ADDENDUM #01

October 29, 2025

TO CONTRACT DOCUMENTS FOR:Project #CP241934 – Memorial Stadium Facilities –
SEZ Recruiting Room Fitout**ADVERTISEMENT DATE:**

CONSULTANT:Simon Oswald Associates, Inc.
2801 Woodard Drive, Suite 103
Columbia, MO 65202
(573) 443-1407

EXT STUD - TYP STOREFRONT HEAD @ MWP

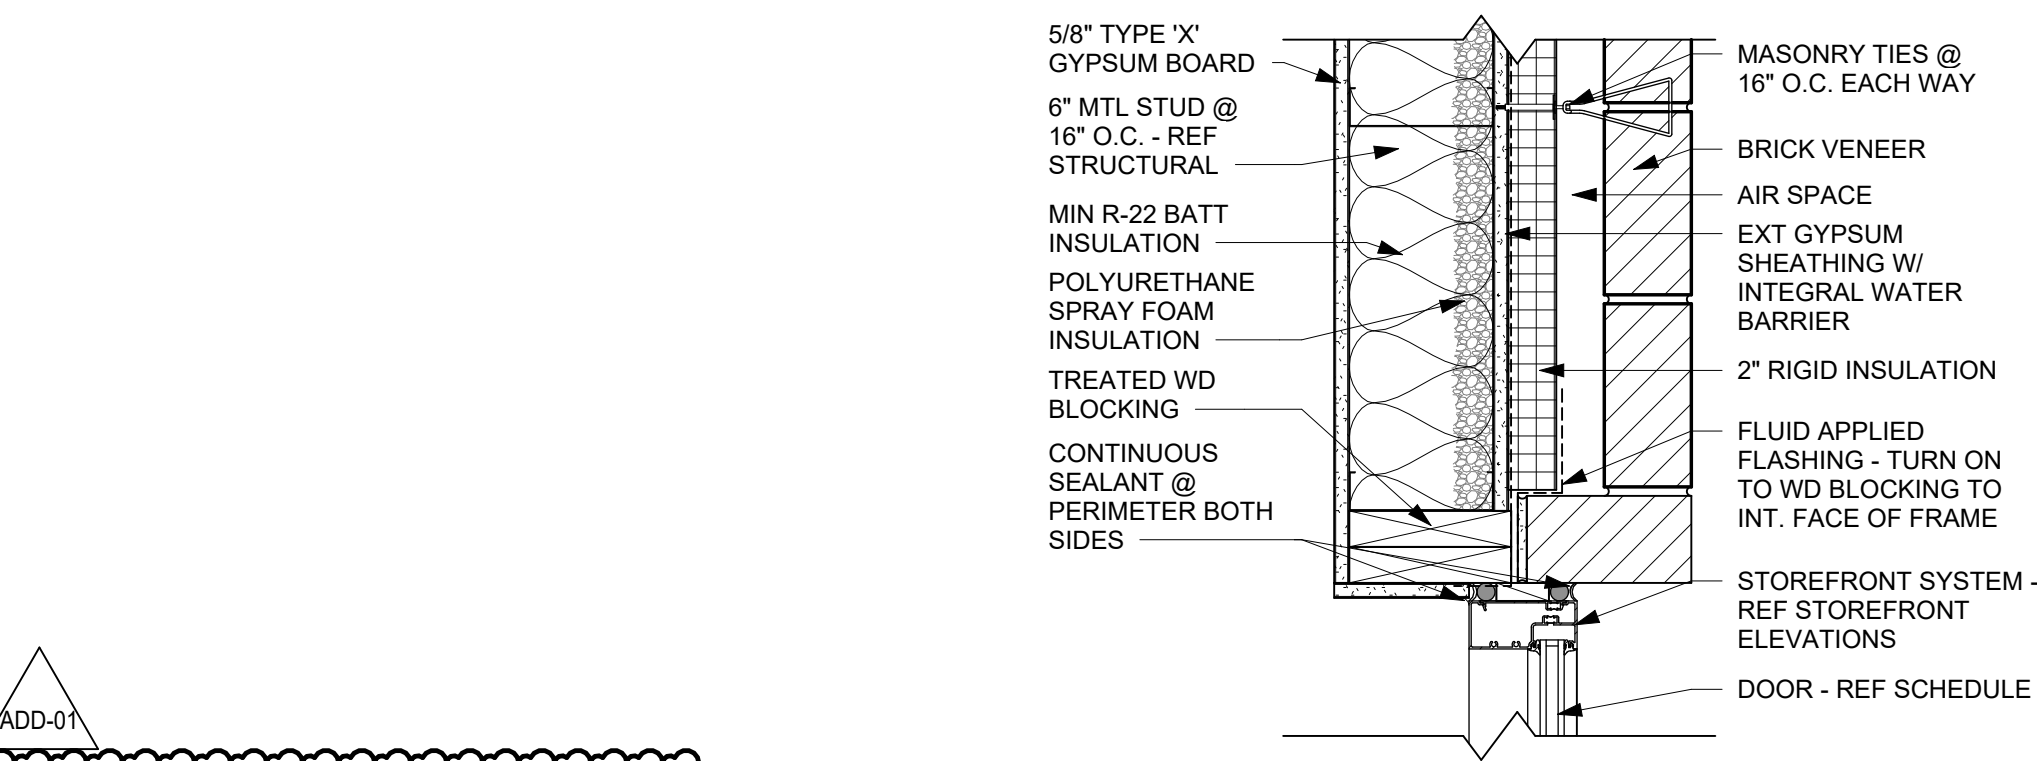
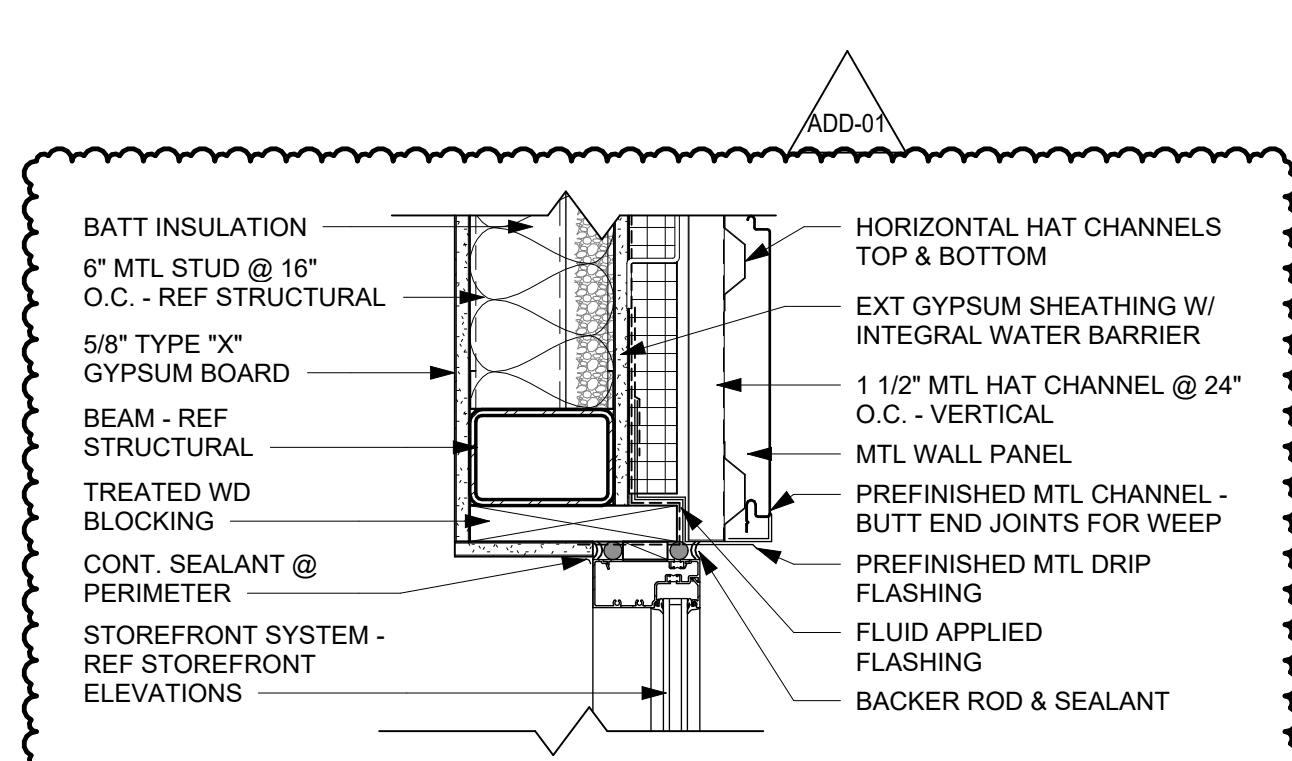
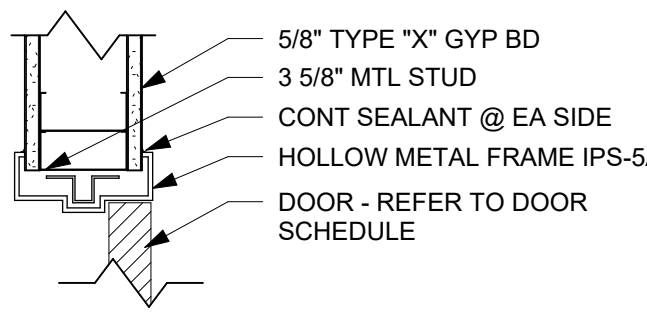
- 7) Drawing sheet A701: **REPLACE** sheet A701 dated 10/02/2025 in its entirety with revised sheet A701 dated 10/29/2025 attached. Revise sheet to eliminate details 02 and 05 that are not applicable. Revise Detail 03 to clarify metal wall panel at top of wall. Revise Elevation 06 to provide dimensions of openings and panel configuration size.

DETAIL 05/A701 NOT USED

DETAIL 02/A701 NOT USED

AREA G - RECRUITING ROOM - LIGHTING PLAN

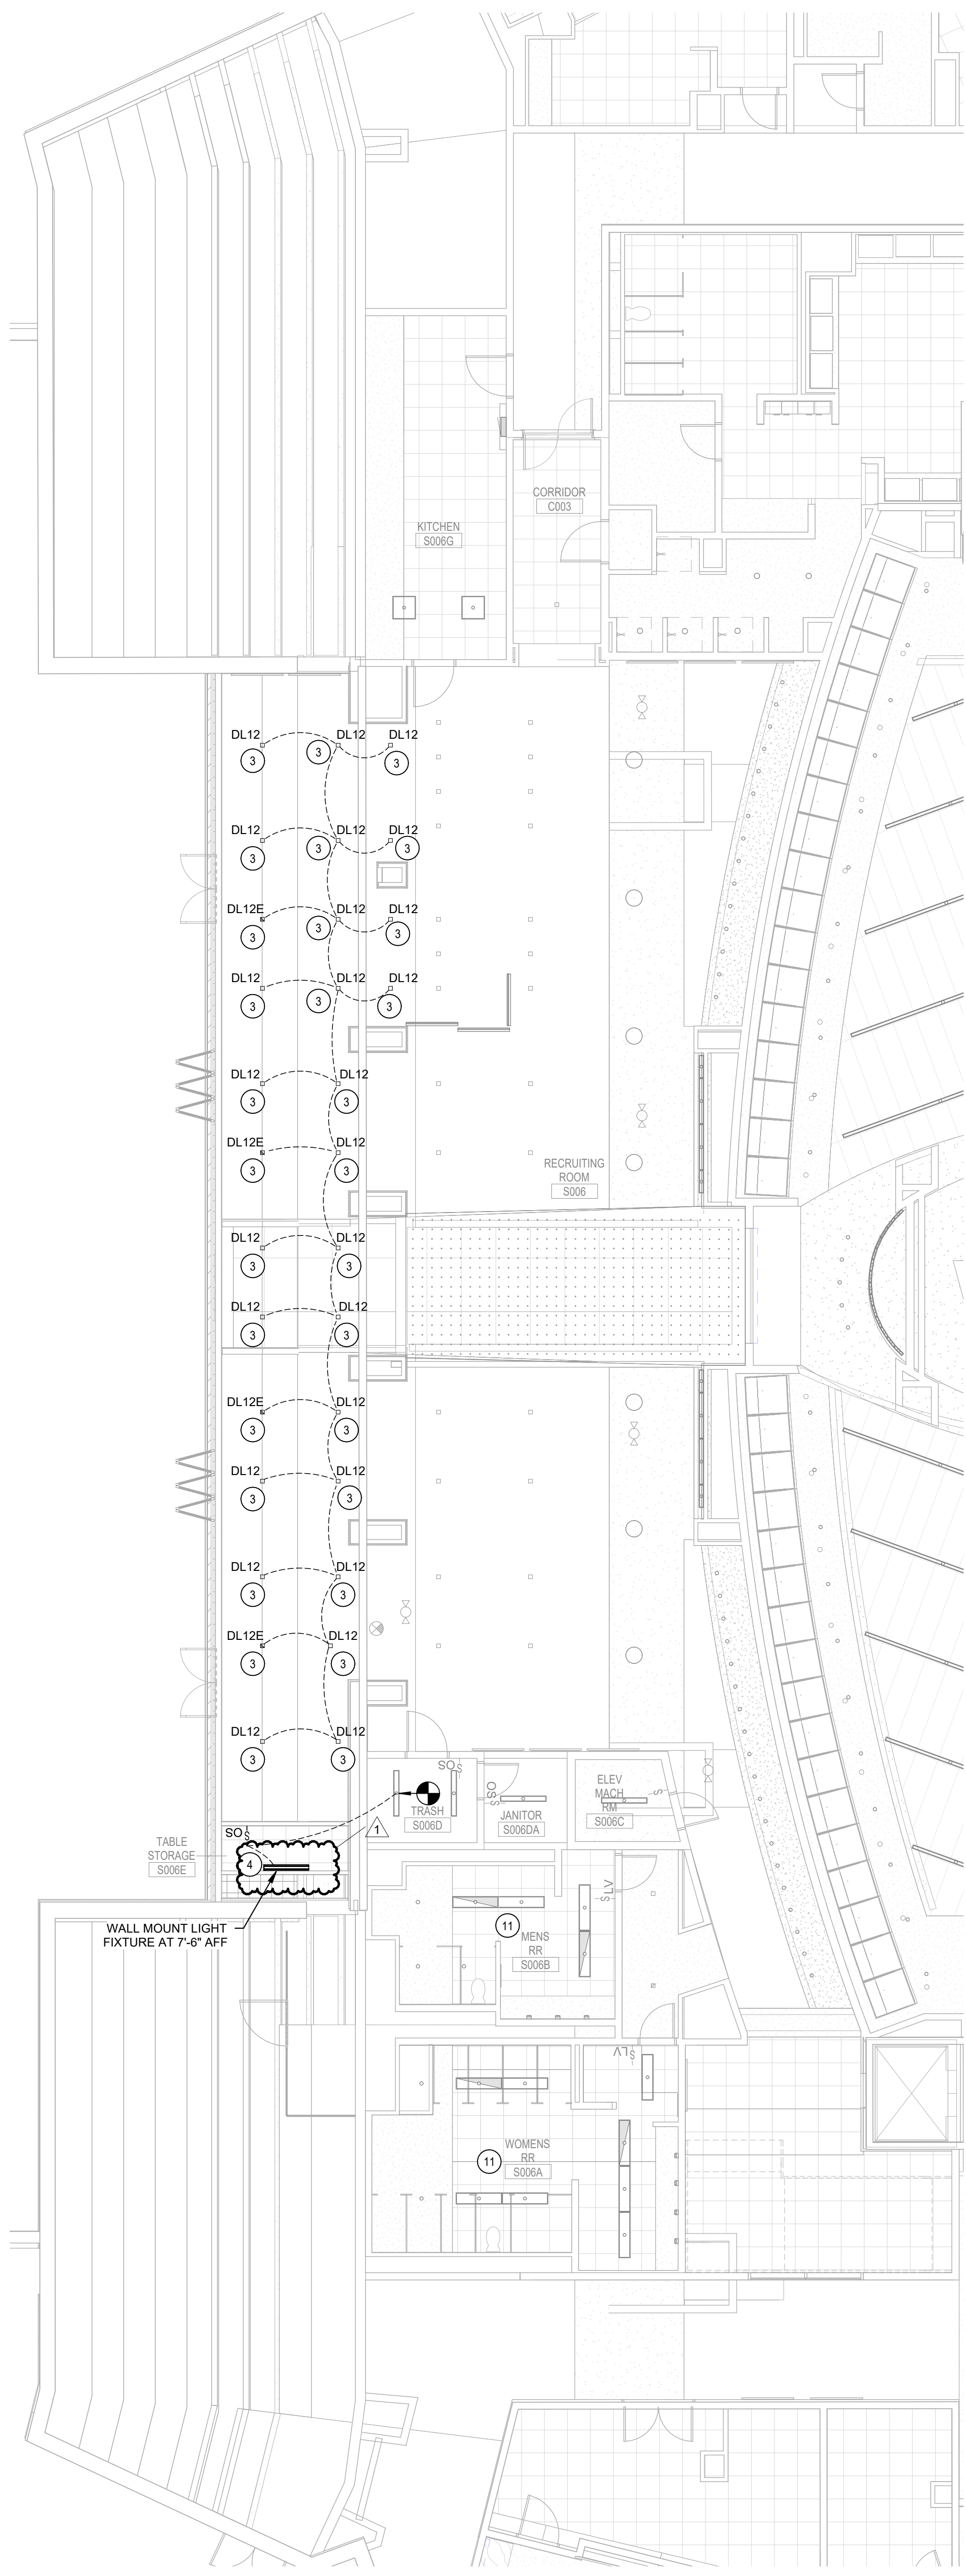
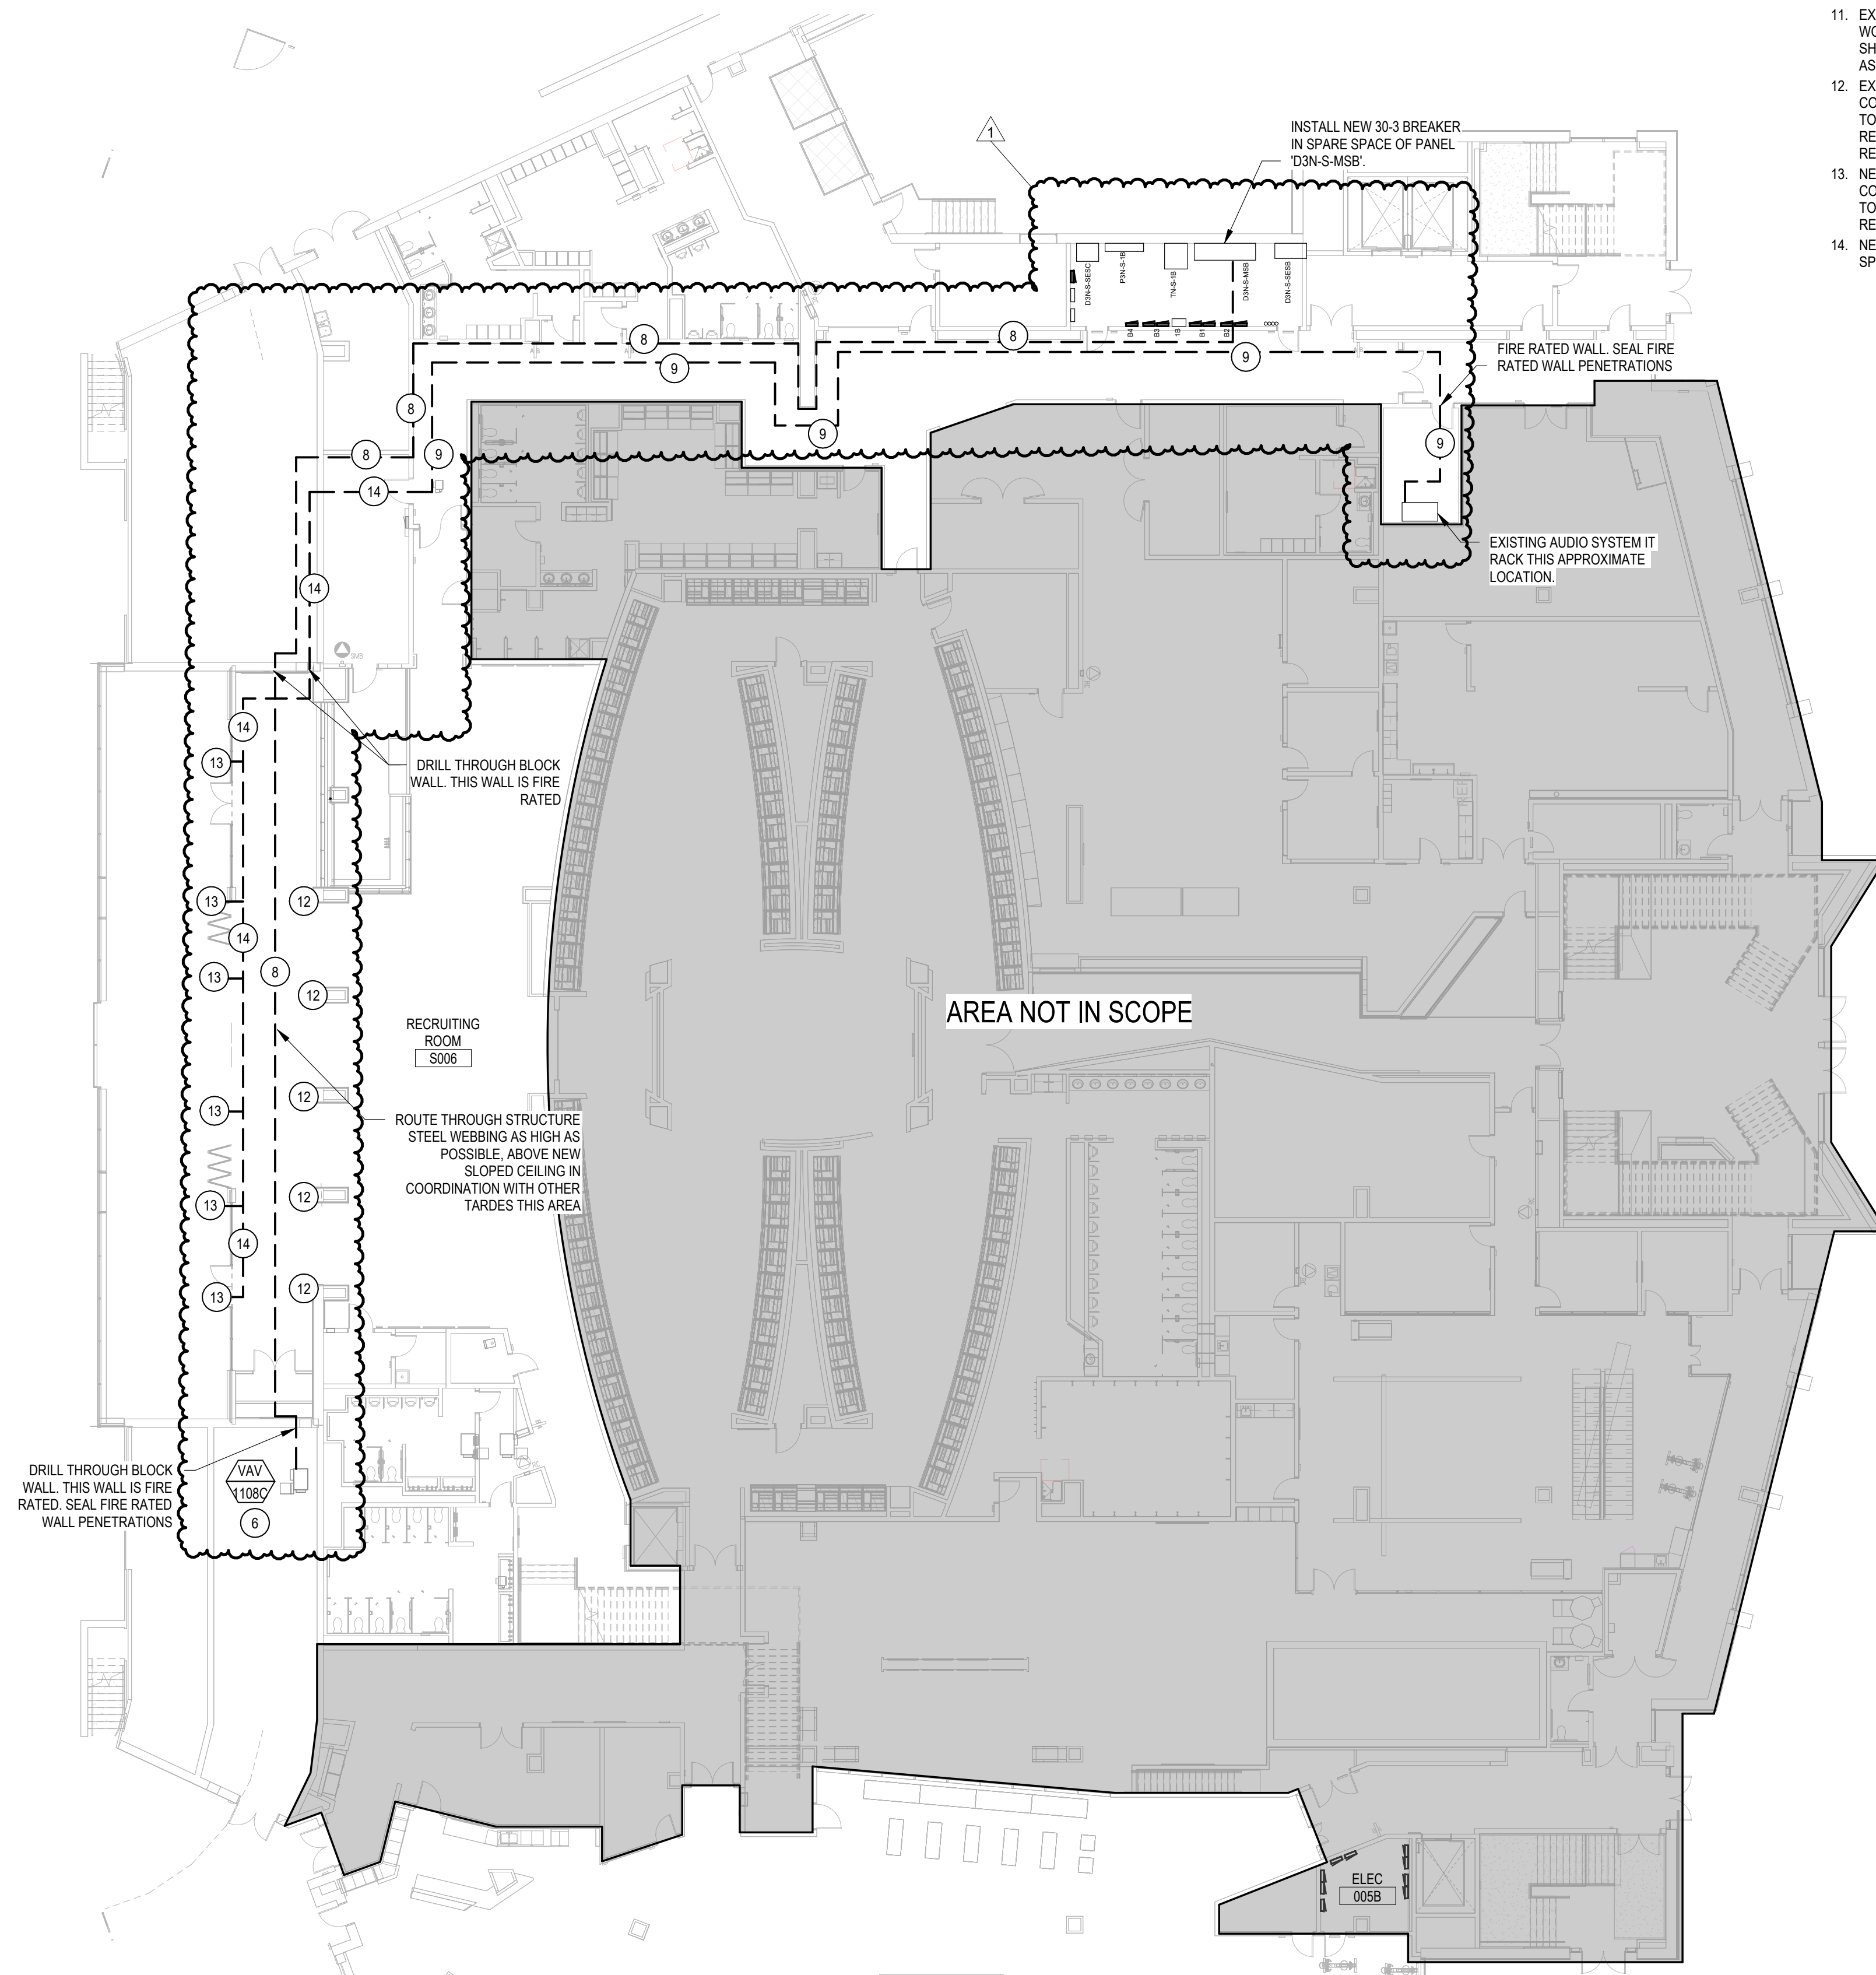
- 9) Drawing sheet E102: **REPLACE** sheet E102 dated 10/02/2025 in its entirety with revised sheet E102 dated 10/29/2025 attached. Revise Lighting Plan to clarify location of wall mounted light fixture in Table Storage S006E. Revise Overall Electrical Plan to update pathway for conduit, conductors and breakers for the new VAV boxes from the East side Electrical room and clarify scope for new speaker wiring.

- ROUTE NEW 12 GA. SPEAKER WIRE ON EXISTING CABLE TRAY THAT FOLLOWS THE APPROXIMATE ROUTING SHOWN. ROUTING SHOWN IS APPROXIMATE AND CONTRACTOR SHALL FIELD VERIFY LOCATION OF CABLE TRAY AND ROUTING PRIOR TO ORDERING MATERIALS. CONTRACTOR SHALL FIELD VERIFY EXISTING SPEAKER WIRE CABLE TYPE AND PROVIDE NEW SAME TYPE AND GAGE WIRE.
